# Access Compliance Report

## Public Rights-of-Way

Intersection ID: 50666	Main Street: SPRINGPOINT_LN	Cross Street: SAMUEL_NEEL_RD	Location: SW
ADA ID: 8D5BFB0440F5	Ramp Type: PerpDiag	Initial Pass/Fail: Fail	Overall Compliance: No
Severity Score: 12.5			
Codes/Mitigation Info/Possible Solution		Field Measurements/Component Compliance

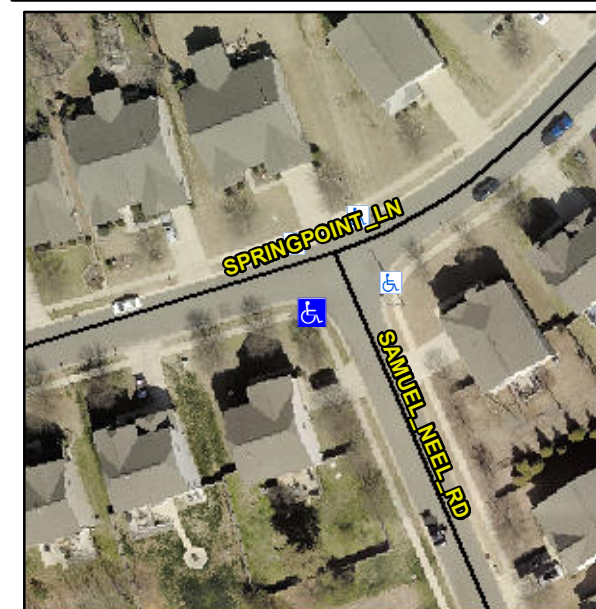
**R304.5.3**

Compliance	Description	Data	Compliance	Description	Data
N/A	Ramp Length (in)	47.0	Yes	Ramp Slope (%)	7.3
Yes	Ramp Width (in)	48.0	No	Ramp XSlope (%)	5.9
N/A	Flare Type LT	N/A	N/A	Flare Type RT	N/A
N/A	Flare Slope LT (%)	N/A	N/A	Flare Slope RT (%)	N/A
N/A	Flare Traversable LT?	N/A	N/A	Flare Traversable RT?	N/A
N/A	Landing Length (in)	N/A	N/A	DWS Provided?	N/A
N/A	Landing Width (in)	N/A	N/A	DWS Contrast?	N/A
N/A	Landing Slope (%)	N/A	N/A	DWS Length (in)	N/A
N/A	Landing X Slope (%)	N/A	N/A	DWS Full Width?	N/A
N/A	Landing Curb? (Y/N)	N/A	N/A	DWS Offset (in)	N/A
N/A	Shared Landing?	N/A			
N/A	Gutter Ponding?	N/A	N/A	Gutter Slope (%)	N/A
N/A	Gutter Lip Ht (in)	N/A	N/A	Gutter X Slope (%)	N/A
N/A	Painted X Walk1?	No	N/A	Painted X Walk2?	No
	X Walk 1 Direction	To NE		X Walk 2 Direction	To NW
N/A	X Walk 1 Width (in)	N/A	N/A	X Walk 2 Width (in)	N/A
	X Walk 1 Slope (%)	7.5		X Walk 2 Slope (%)	5.8
	X Walk 1 X Slope (%)	2.2		X Walk 2 X Slope (%)	6.3

**Remove & Replace Curb Ramp With Two New Directional Ramps or Equivalent.**
